**PERMIT MODIFICATION**

**WHITE STREET LANDFILL**  
**GREENSBORO, NORTH CAROLINA**

**Prepared for:**  
**City of Greensboro, North Carolina**

Re: White Street Landfill Phase III Permit Modification (Permit No. 41-12)  
Greensboro, North Carolina  
HDR Project No. 06770-67286-001

<b>FINAL CONTOURS AND DRAINAGE PLAN</b>		Date	MARCH 2008	Project No.	6770-021-018	Fig. No.	C-7A	Issue	A2
		Scale	1"=100'

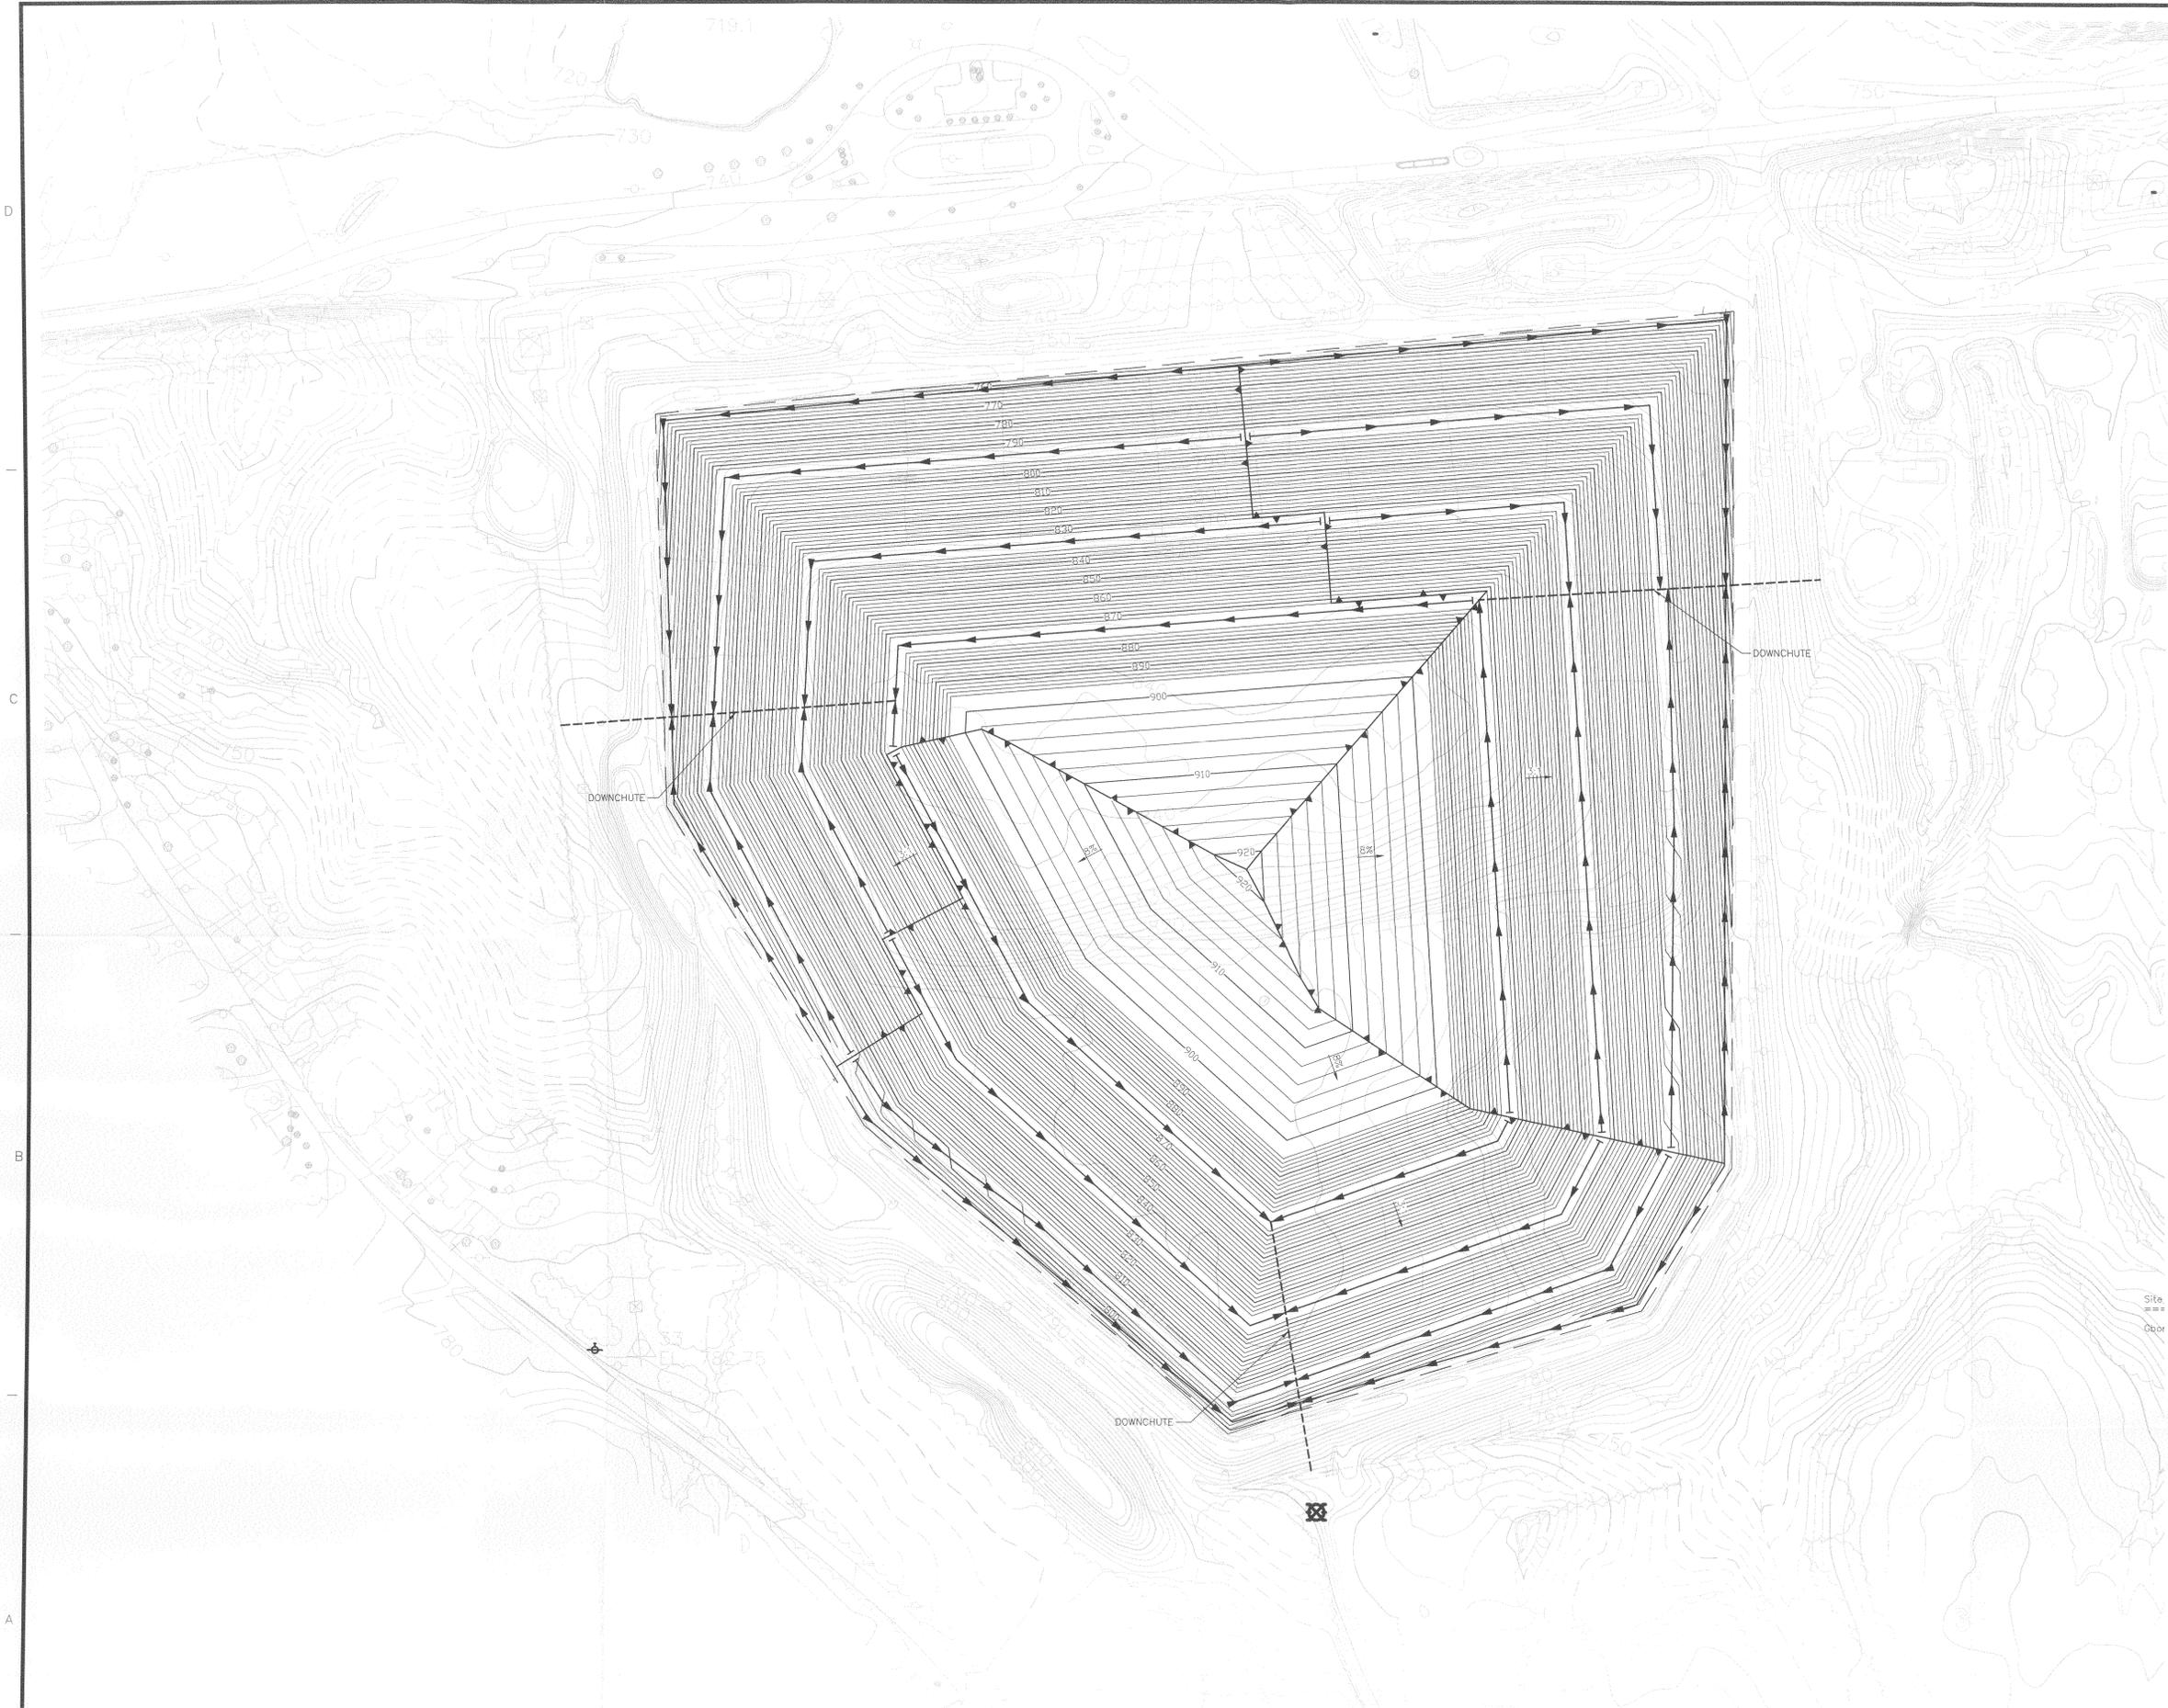
Drawing C-7A has been revised to show the proposed revised final cover slope of 33%. Design of the drainage control features for the original permitted contours were based on guidelines and procedures as set forth in the North Carolina Erosion and Sediment Control Planning and Design Manual (E&SCP&DM) and "Elements of Urban Stormwater Design" (EOUSD), by H. Rooney Malcom, P.E. This system included a series of diversion berms, downchutes, benches, and channels which will convey stormwater runoff from the cover system to multiple sediment basins located adjacent to the sanitary landfill. Drawing C-7A has been revised to show drainage consistent with the new location of benches on the 3H:1V slope. The area of drainage to each sediment basin was kept consistent with the original design and therefore no new erosion and sedimentation calculations have been included.

Issue No.	Description	Date	Drawn	Checked	Appr. Engr.	Proj. Mgr.
A2	REVISED FINAL CONTOURS TO A 3H:1V SLOPE AND UPDATED THE EXISTING TOPOGRAPHY	3/6/08	JEG	DTD	JCR	JCR
A1	REVISED AS PER NCDENR COMMENTS DATED 2/25/97	2/26/97	JEG	DTD	JCR	JCR
A	ISSUED FOR DEHNR APPROVAL	11/28/95	JEG	EAW	JCR	JCR
